WJ-NX300K, WJ-NX300K/G
New functions and revisions (Software V4.40)

WJ-NX300K, WJ-NX300K/G
New functions and revisions (Software V4.30)

WJ-NX300K, WJ-NX300K/G
New functions and revisions (Software V4.20)

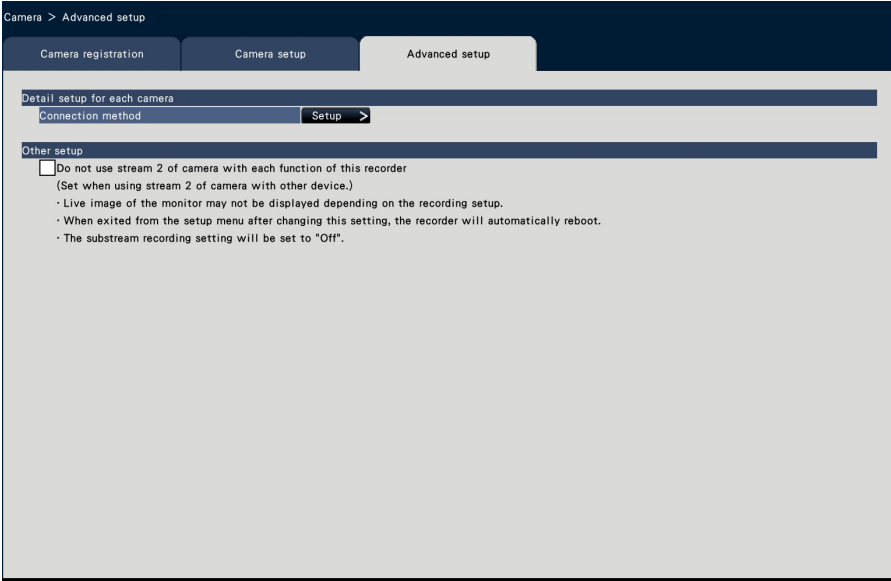
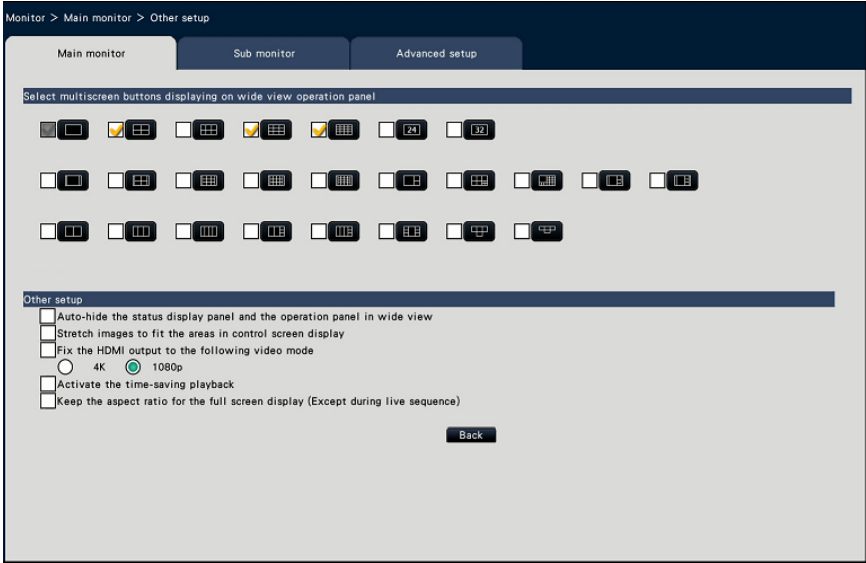
Details on the new functions and revisions	Reference pages
The function of setting Schedule mode and Schedule range for individual cameras is added.	Page 33

Set schedule [Schedule 1 to Schedule 4]
Select the Schedule mode and Schedule range for individual cameras and transfer to the camera to change the camera settings.

[Schedule]
Check the boxes for the day you want to set the schedule range. Set the start time and the end time when you want to specify a time period. Check "24 h" when the time period is not set.

■ Camera selection
Select the camera to which the setting of the "Schedule" is to be sent. Mark the checkbox of the camera to which the setup information is to be transmitted.

[Transmission] button
Transmit the setting of the "Schedule" to the camera.
Once transmission is completed and the setting has been applied to the camera, "OK" will be displayed in the "Results" field. If the display reads "Authentication error", etc., the camera connection or the setting may have failed.

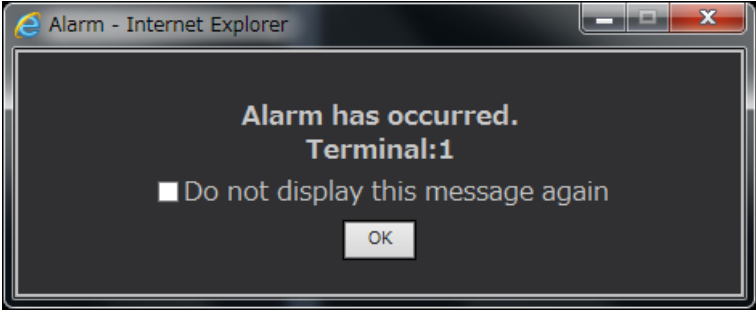
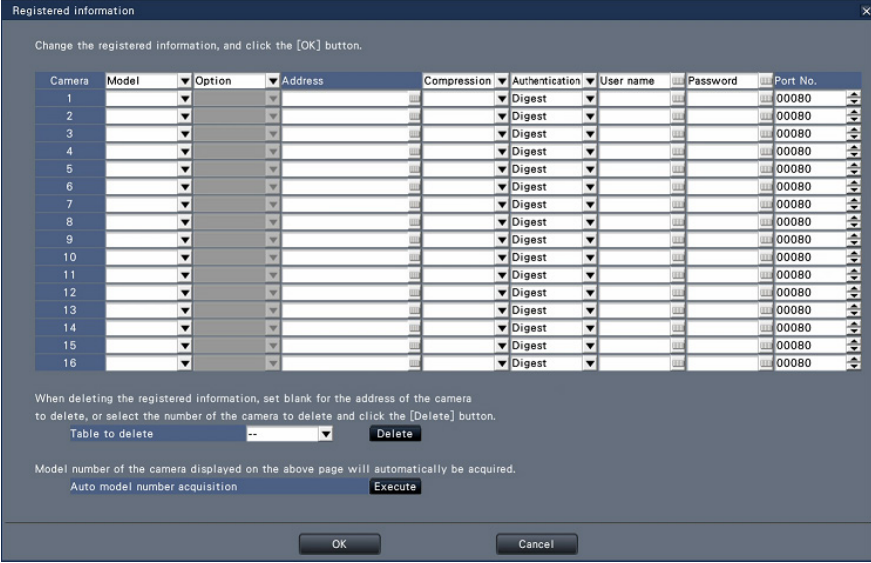
Details on the new functions and revisions	Reference pages
Functions to format and remove HDDs without stopping recording are added. **[HDD Maintenance]** Set a password for the HDD viewer, format and remove HDDs. Click the [Setup >] button for HDD maintenance. The single mode screen is used for explanation. **[Format HDD]** Select a HDD to format and click the [Start] button to format the HDD. **Important:** 　•When a hard disk drive is formatted, all the recorded images will be erased. 　•HDDs with "Playback only" or "Added" status only can be selected. 　•After starting to format the HDD, copying and downloading in process will stop **[Remove HDD]** Select a HDD to remove and click the [Start] button to display the password confirmation window for the HDD viewer. When the entered value and the setting match, the HDD is removed. **Important:** 　•HDDs in recording cannot be selected. If the HDD stand-by control mode is On, a HDD following the HDD in recording also cannot be selected. If the operation mode of HDDs is the mirroring mode, one of the two HDDs in recording may be removed. 　•After starting to remove the HDD, copying and downloading in process will stop.	Page 64
